**Nishkam School West London,
Syon Lane, Hounslow**

Stage 1 Road Safety Audit

| Report Ref: | 8838/AND/001/01 | August 2015 | |

APPENDIX A
Marked Up Plan

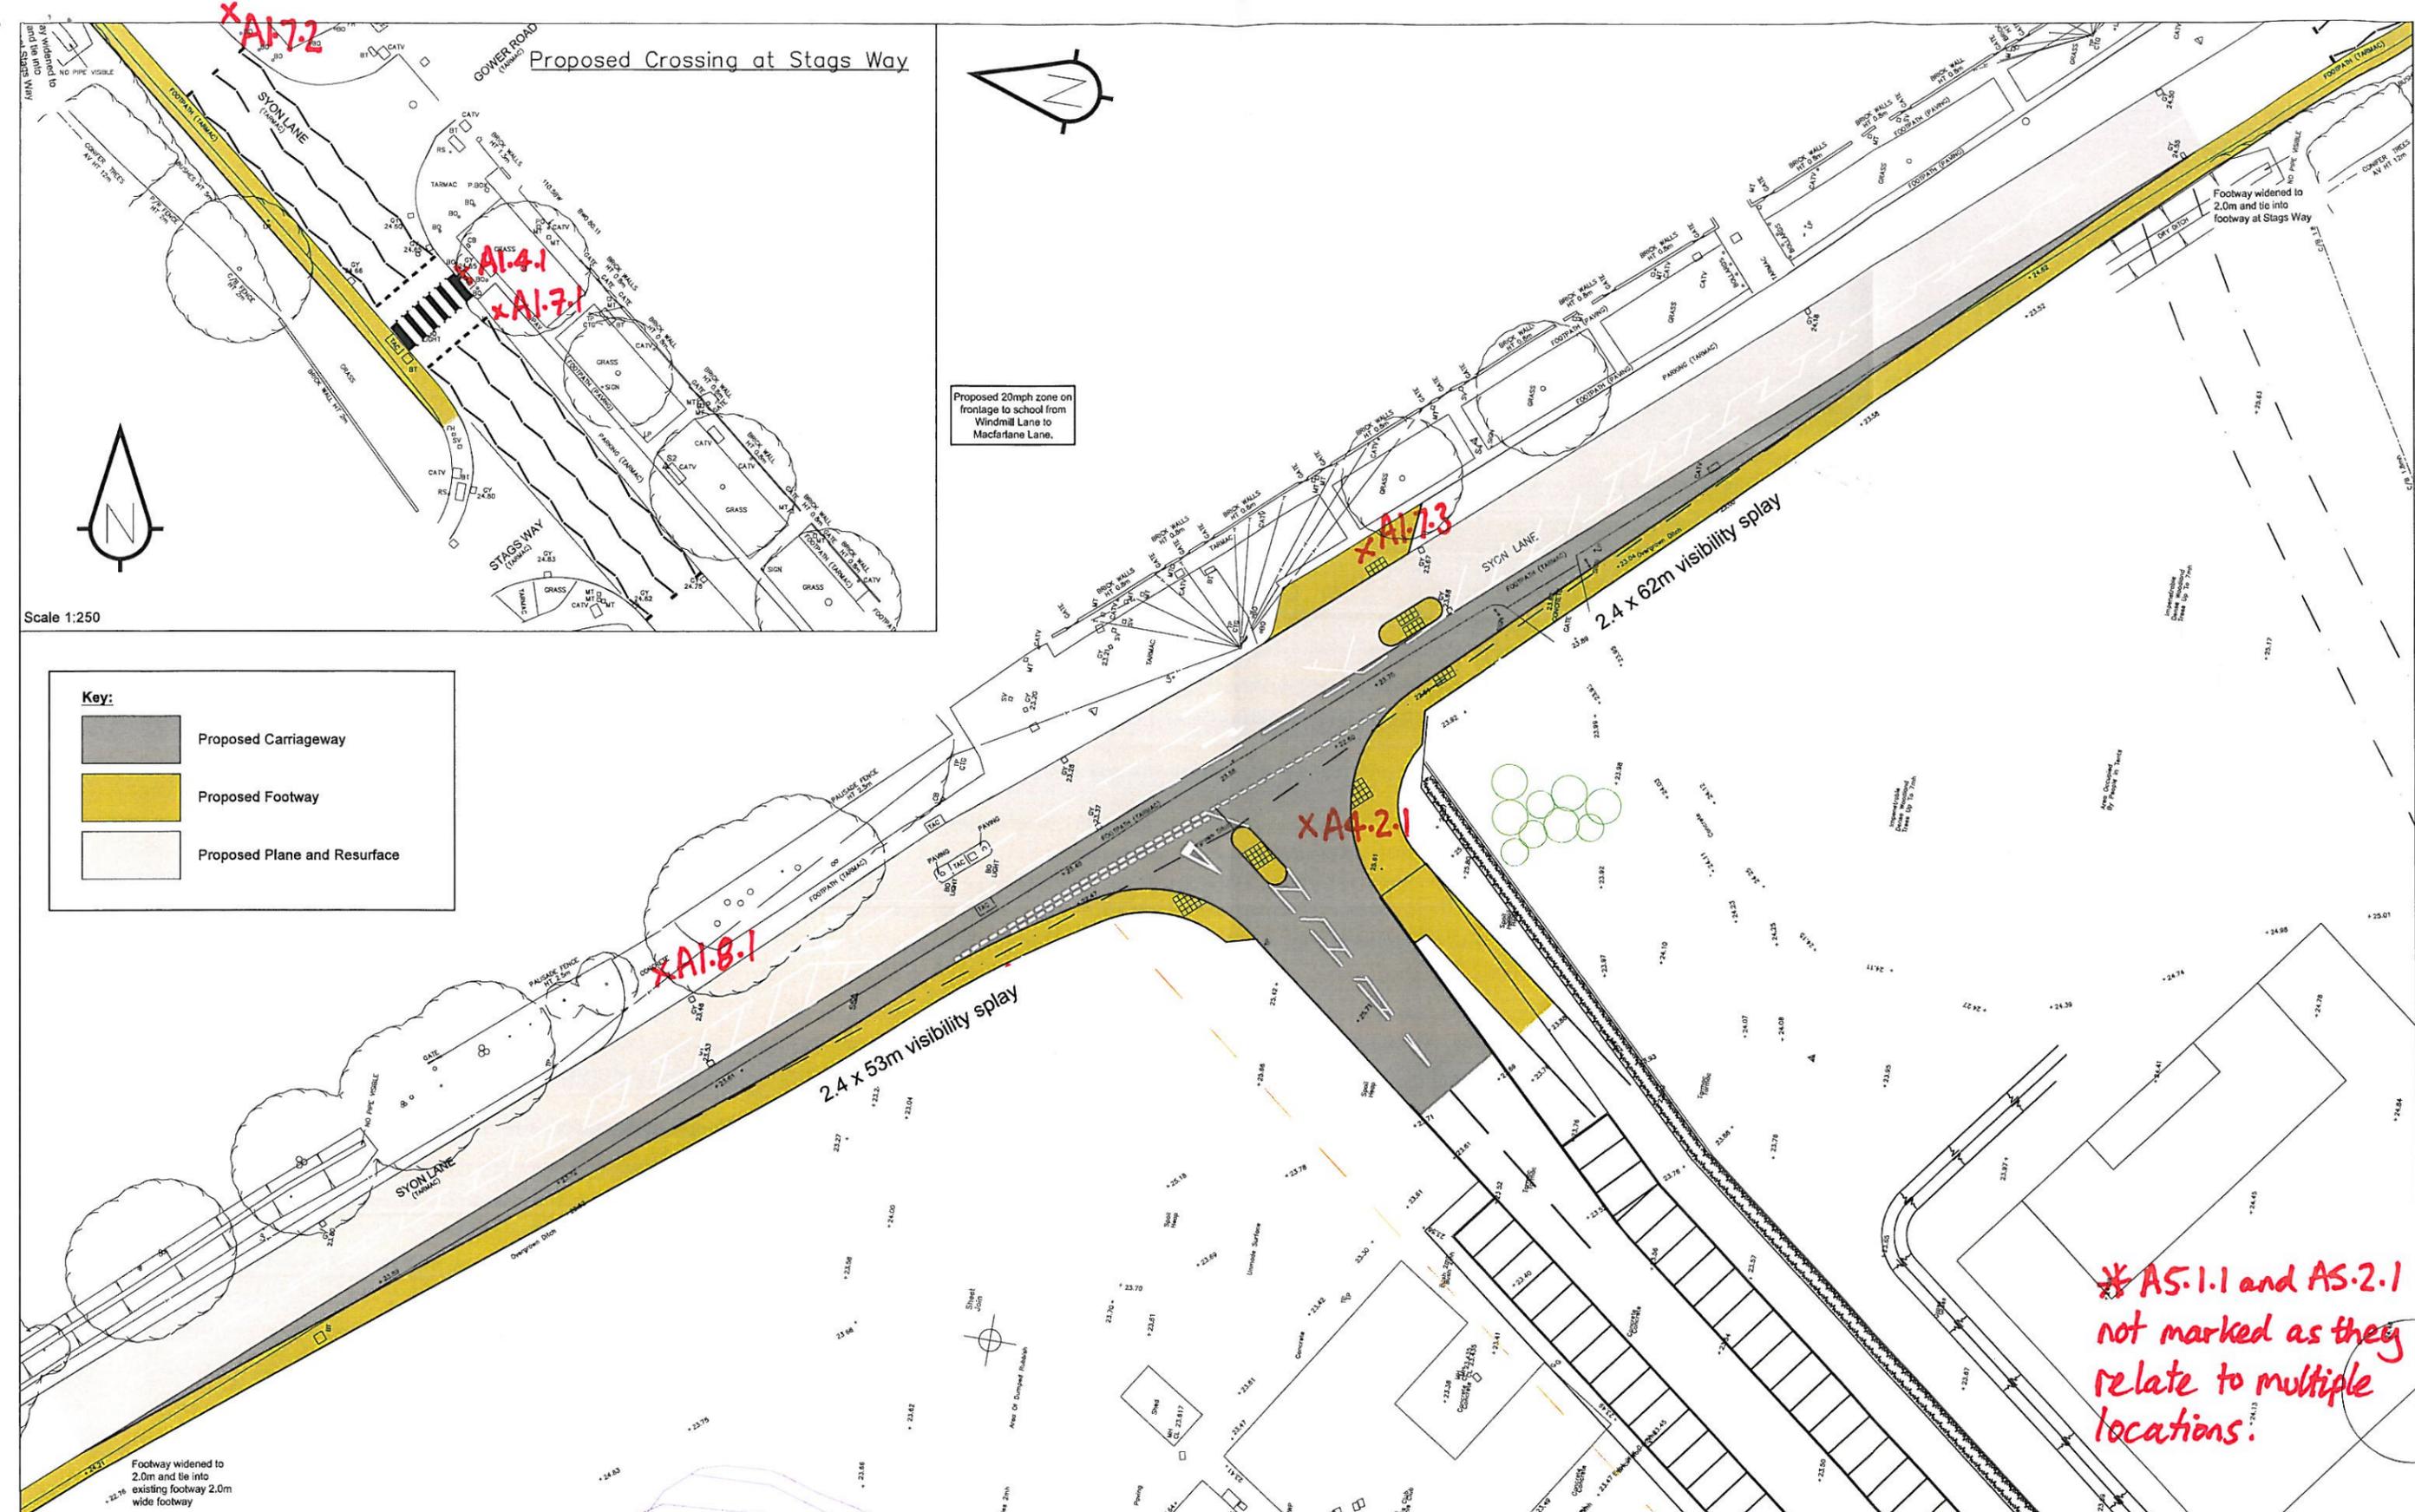
A1.2.1 **Problem:** Cross-sectional variation

Summary: The proposed site access includes carriageway widening on the west side of Syon Lane to accommodate the proposed ghost island right turn lane. This results in the back of footway being set back closer to a dry ditch that runs along the rear of the easting footpath. Should adequate protection not be provided, pedestrians could trip and fall into the ditch.

A1.4.1 **Problem:** Drainage

Summary: A road gully exists on the east side of the existing uncontrolled pedestrian crossing, located within the existing tactile paving. This uncontrolled crossing is proposed to be replaced by a zebra crossing, which will require alterations to the existing tactile paving. There is evidence of ponding in this location, with debris present on the tactile paving. Should the gully remain in its current location, this could result in ponding continuing to occur on the footway adjacent to the crossing, which would create slip hazard for pedestrians. The gully grate is also not a pedestrian friendly design and could cause trips or cause problems for pedestrians who use sticks etc.

A1.7.1 Problem: Lay-bys

Summary: There is a parking lay-by on the east side of Syon Lane, immediately to the south of the proposed zebra crossing. Should a high sided vehicle park in the lay-by this would block visibility for pedestrians waiting on the east side of the crossing. This would make it more difficult for pedestrians to observe and be observed by an oncoming northbound vehicle, which could result in pedestrian/vehicle collisions or rear shunts associated with vehicles braking heavily to stop at the crossing.

A1.7.2 Problem: Lay-bys

Summary: Similar to point A1.7.1, there is a parking lay-by on the east side of Syon Lane, to the north of the proposed zebra crossing and Gower Road. Whilst the majority of the vehicles observed parking in the lay-by parked parallel to kerb, one vehicle in the most southern part of the lay-by had parked perpendicular to the kerb, which is possible as the lay-by is sufficiently deep to do so. This vehicle blocked visibility for pedestrians waiting on the east side of the crossing to southbound traffic. This would make it more difficult for pedestrians to observe and be observed by an oncoming southbound vehicle, which could result in pedestrian/vehicle collisions or rear shunts associated with vehicles braking heavily to stop at the crossing.

A1.7.3 Problem: Lay-bys

Summary: A buildout is proposed on the east side of Syon Lane to provide an uncontrolled crossing point, at the proposed pedestrian refuge immediate to the south of the proposed site access. This would remove some of the available lay-by parking, which appears to be heavily used as most of the adjacent properties do not benefit from having a drive. The removal of these parking spaces is likely to displace parking elsewhere on Syon Lane and surrounding streets and may encourage these motorists to park in inappropriate locations. Depending on where parking is displaced, this may cause a variety of safety issues, such as causing an obstruction or blocking sight lines if parking occurs close to junctions etc.

A1.8.1 Problem: Access

Summary: There is a car park access on the east side of Syon Lane to the north of the proposed site access, which is opposite the taper of the proposed ghost island right turn lane. No provision has been made to provide a right turn lane to enable access to the car park. Instead, drivers would be required to cross through the proposed hatch markings. As the road markings do not direct drivers on how to access the car park safely, vehicles waiting to turn right into the car park access could be badly positioned and impede passing traffic. This could result in rear shunt type collision with northbound vehicles, or collisions with southbound vehicles entering the proposed right turn lane.

A4.2.1 Problem: Pedestrian/Cyclists

Summary: The dropped crossing and pedestrian refuge island proposed to enable pedestrians to cross the site access is located quite close to Syon Lane. This makes the crossing distance on the inbound lane approximately 8m wide. As the crossing is likely to be heavily used by school children when the junction is at it busiest at the start and end of the school day, the risk of collisions between turning vehicles and pedestrians may be high.

A5.1.1 Problem: Signs

Summary: There are trees and parking lay-bys on the east side of Syon Lane, which restrict visibility to the proposed zebra crossing, which will make it less conspicuous. Should approaching vehicles fail to observe the crossing, this could result in pedestrian/vehicle collisions, or rear shunt type incidents associated with late braking.

A5.2.1 Problem: Road Markings

Summary: The proposed site access and the proposed zebra crossing to the south of Gower Road will require alterations to the existing street lighting to ensure that they are adequately illuminated. However, as with some of the existing lighting columns, they may become obscured by tree branches. Should inadequate lighting be provided, this could contribute to a variety of incidents and in particular increase the potential for pedestrian/vehicle collisions.

Recommendation: If possible remove the ditch. If this is not practical, provide a fence or other boundary treatment to prevent pedestrians from entering the ditch.

Recommendation: Relocate the gully into the carriageway away from the pedestrian desire line.

Recommendation: Pedestrian visibility should be improved. This could be done by removing or setting back some of the lay-by parking, or possibly by introducing a buildout to enable pedestrians to look passed the lay-by without stepping in to the carriageway.

Recommendation: If the lay-by were marked to indicate to drivers to park parallel to the kerb at the rear of the lay-by, this would help control the use of the layout and prevent vehicles from blocking visibility.

Recommendation: Ideally the lost parking spaces should be replaced elsewhere nearby if possible. However, as this may not be possible, it would be possible to introduce markings in the remaining lay-by (as already suggested in A1.7.2) to encourage a good parking regime that maximises the available space.

Recommendation: Provide facilities for right turning vehicles into the car park access.

Recommendation: Set back the pedestrian crossing point further into the site access to reduce the pedestrian crossing distance.

Recommendation: Provide advanced warning signage for the pedestrian crossing. Careful consideration of the sign locations should be given, as it was observed on site that an existing sign (bend ahead sign) of the east side of Syon Lane to the south of the proposed crossing is currently obscured by tree branches. A similar situation should be avoided for any proposed signage.

Recommendation: Ensure that adequate lighting columns are provided and that trees branches do not reduce their effectiveness.
